# Access Compliance Report

## Public Rights-of-Way (Curb Ramps)

Intersection ID: 44929	Main Street: TWIN_BROOK_DR	Cross Street: NATHAN_DR	Location: W
ADA ID: 8EB57024B24A	Ramp Type: Perpendicular	Initial Pass/Fail: Fail	Overall Compliance: No
Severity Score: 8.75			
Codes/Mitigation Info/Possible Solution		Field Measurements/Component Compliance

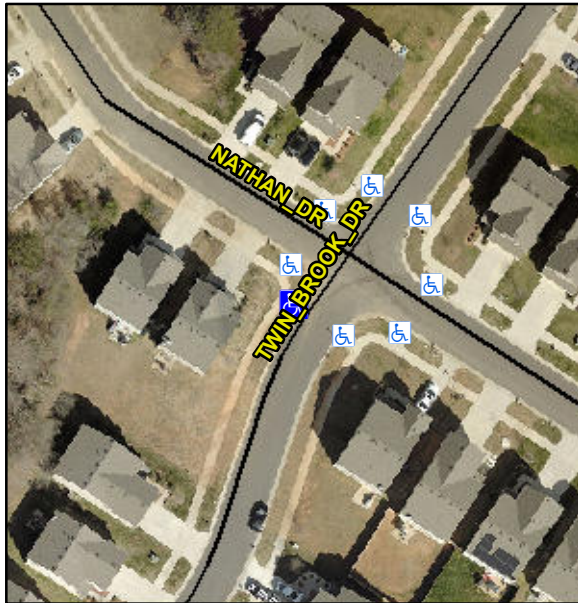
**Not Found, R304.5.1**

Compliance	Description	Data	Compliance	Description	Data
N/A	Ramp Length (in)	96.0	Yes	Ramp Slope (%)	6.9
No	Ramp Width (in)	43.0	Yes	Ramp XSlope (%)	0.1
N/A	Flare Type LT	N/A	N/A	Flare Type RT	N/A
N/A	Flare Slope LT (%)	N/A	N/A	Flare Slope RT (%)	N/A
N/A	Flare Traversable LT?	N/A	N/A	Flare Traversable RT?	N/A
N/A	Landing Length (in)	N/A	N/A	DWS Provided?	N/A
N/A	Landing Width (in)	N/A	N/A	DWS Contrast?	N/A
N/A	Landing Slope (%)	N/A	N/A	DWS Length (in)	N/A
N/A	Landing X Slope (%)	N/A	N/A	DWS Full Width?	N/A
N/A	Landing Curb? (Y/N)	N/A	N/A	DWS Offset (in)	N/A
N/A	Shared Landing?	N/A			
N/A	Gutter Ponding?	N/A	N/A	Gutter Slope (%)	N/A
N/A	Gutter Lip Ht (in)	N/A	N/A	Gutter X Slope (%)	N/A
N/A	Painted X Walk1?	No	N/A	Painted X Walk2?	N/A
	X Walk 1 Direction	To SE		X Walk 2 Direction	N/A
N/A	X Walk 1 Width (in)	N/A	N/A	X Walk 2 Width (in)	N/A
	X Walk 1 Slope (%)	4.6		X Walk 2 Slope (%)	N/A
	X Walk 1 X Slope (%)	0.3		X Walk 2 X Slope (%)	N/A

**Remove & Replace Entire Ramp.**
